CHANGE NOTE RADIO SWITCH DEVICE

This document describes the changed modulation circuitry at radio switch devices. Due to a production discontinuation of the transistor BSS83 we need to replace this transistor by a substitute and change the modulation circuitry to fit to the new transistor.

Picture 1: Old circuitry with BSS83 MOSFet.

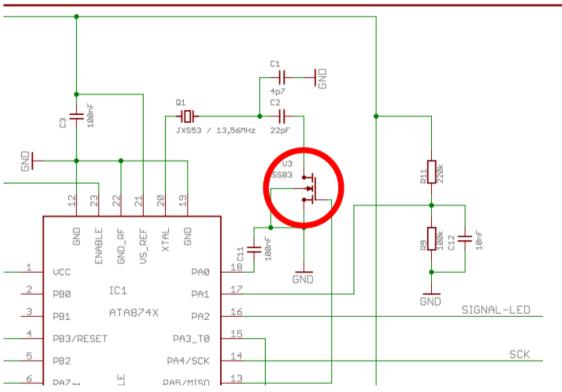
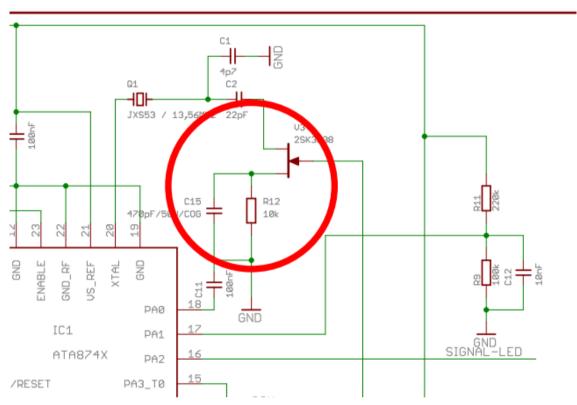
V3, the MOSFet which is responsible for the frequency shift is replaced by an JFet and an additional capacitor and resistor. See Picture 1 (Old circuitry) and Picture 2 (New circuitry).

Picture 2: New Circuitry with JFET and additional resisor and capacitance.
